Subject: USNRC Docket No. 71-9261; TAC No. L22085  
HI-STAR 100 Transportation CoC 9261  
License Amendment Request 9261-1, Supplement 2

Enclosures: 1. Replacement SAR page 2.R-7, proposed Revision 9 (1 page)  
2. QUAD+ Criticality Model Sketch (1 page)  
3. Mark-ups of CoC 9261, Appendix A (2 pages)

MCNP Model of QUAD+ Assembly with Dimensions

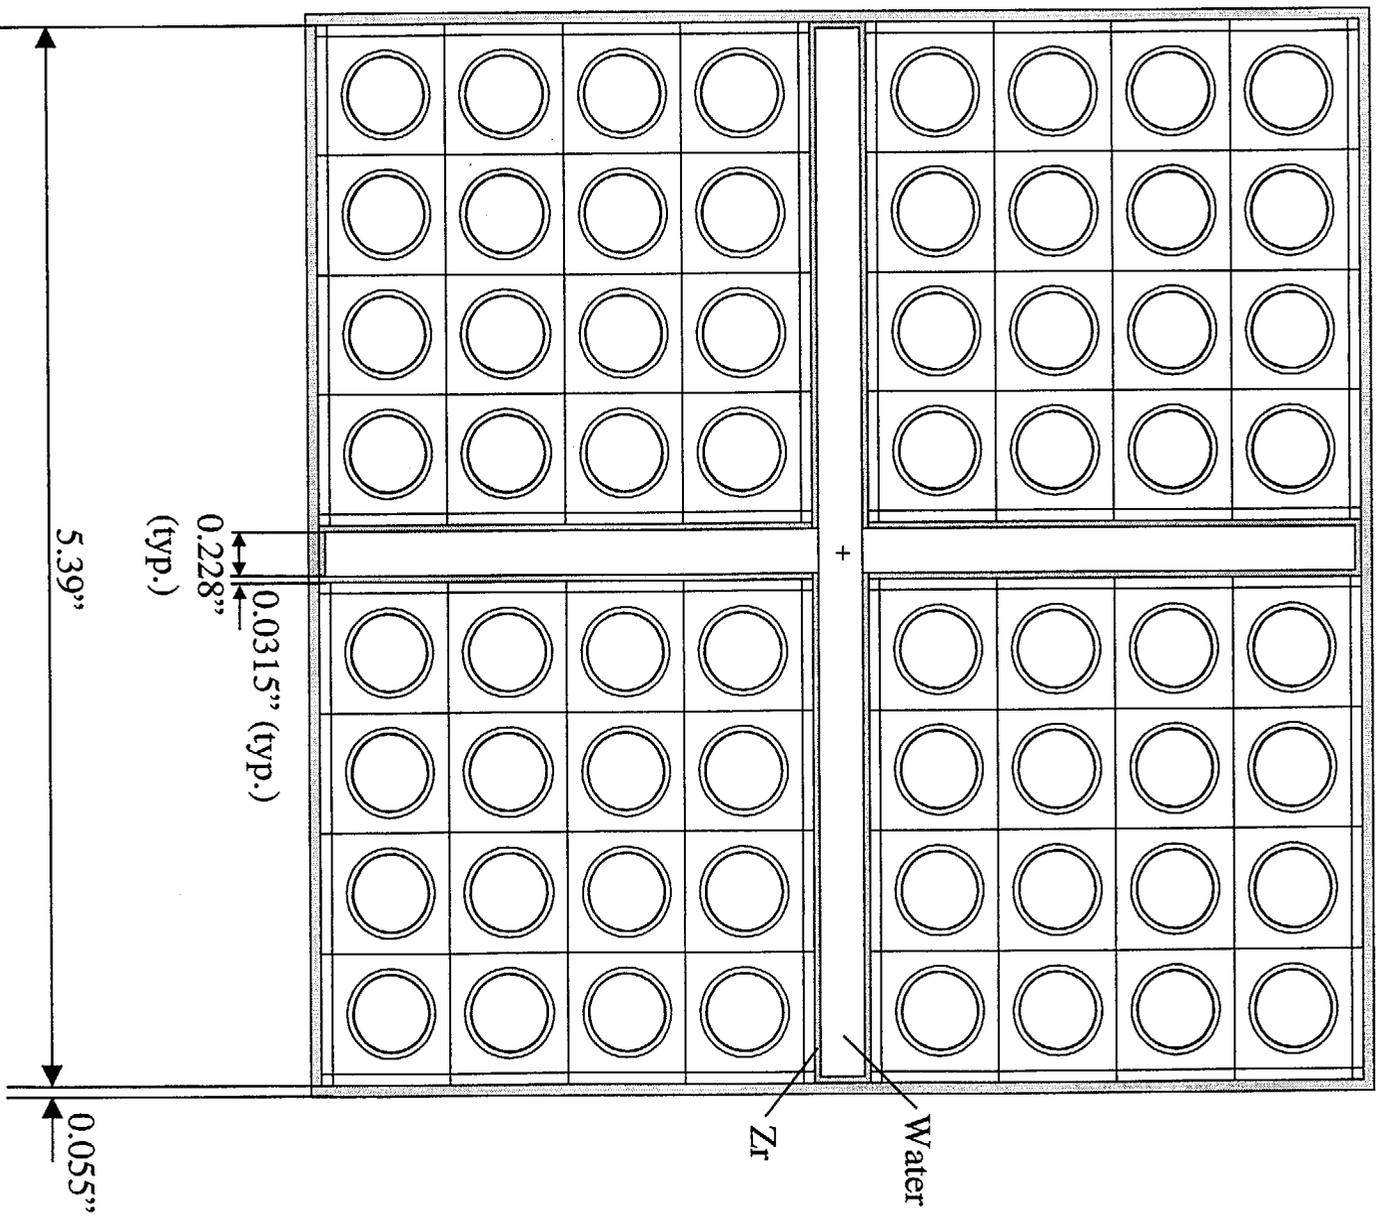
As committed during our telephone conversation yesterday, we enclose herewith replacement pages for proposed Safety Analysis Report (SAR) Revision 9, a sketch of the criticality model of the QUAD+ assembly, and revised wording for the Certificate of Compliance related to the Antimony-Beryllium neutron source. Please note that while the value of  $S_{by}$  presented in Appendix 2.R is different due to a unit conversion, the value used in the underlying calculation is unaffected and the 33% safety margin remains unchanged.
